cROP Significance Determination Process 6-10-10 DRAFT

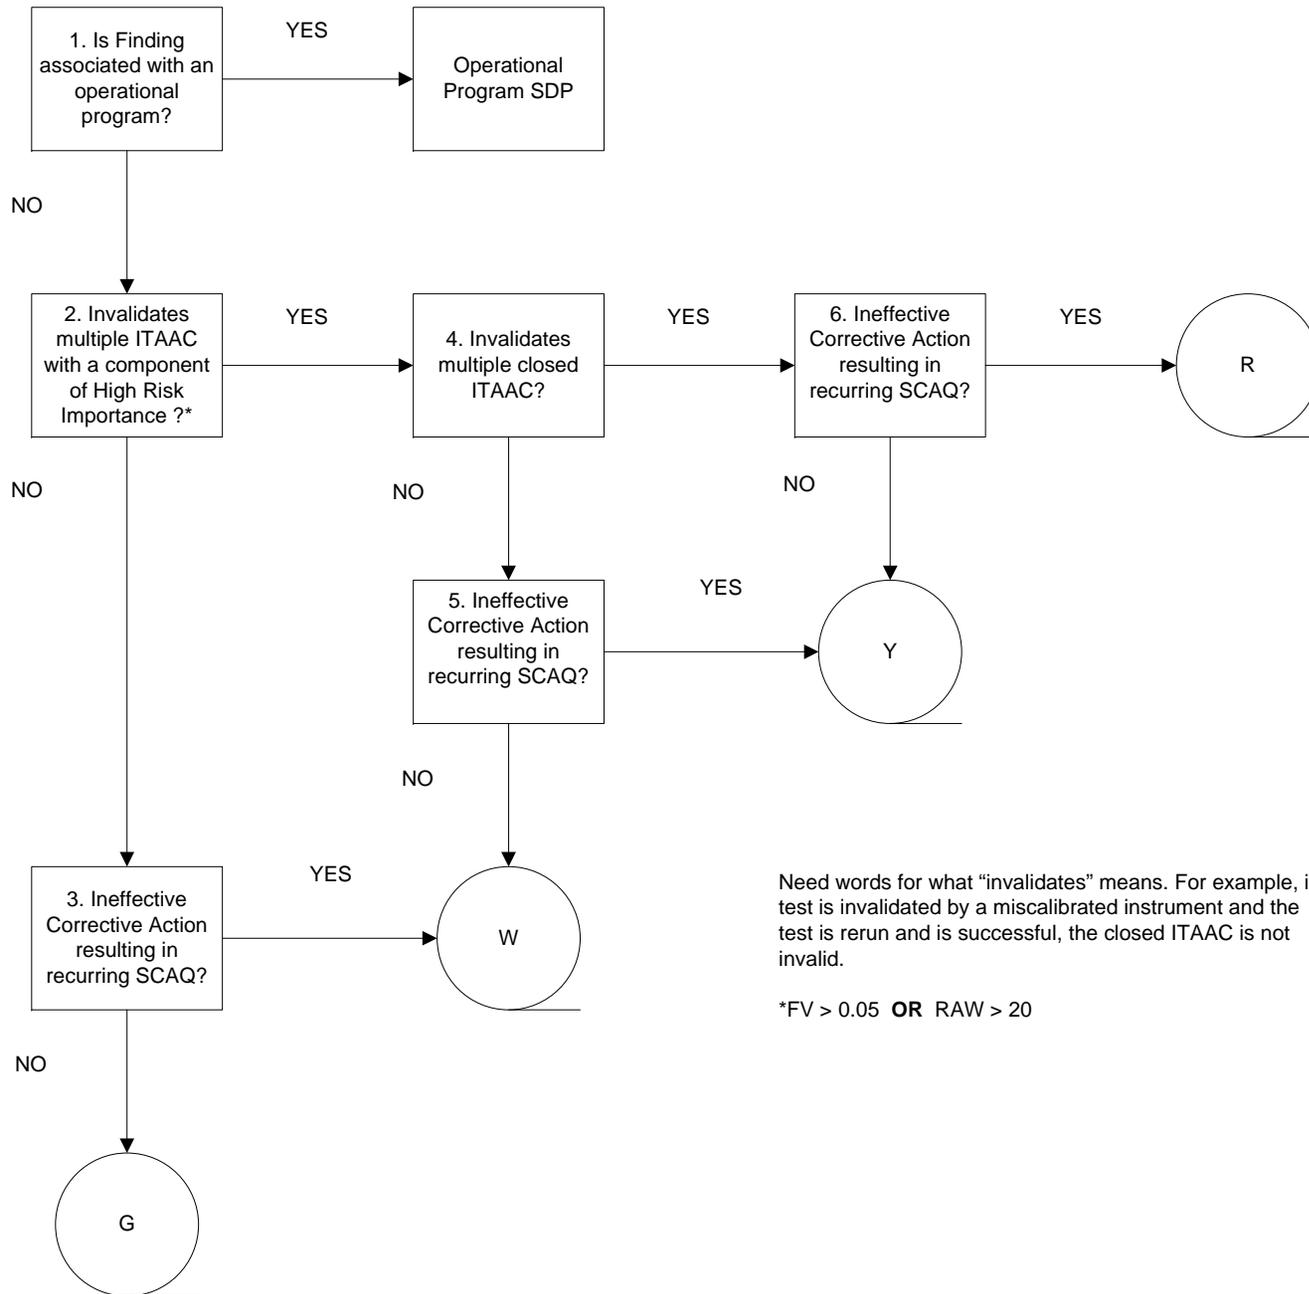
Need words for what “invalidates” means. For example, if a test is invalidated by a miscalibrated instrument and the test is rerun and is successful, the closed ITAAC is not invalid.
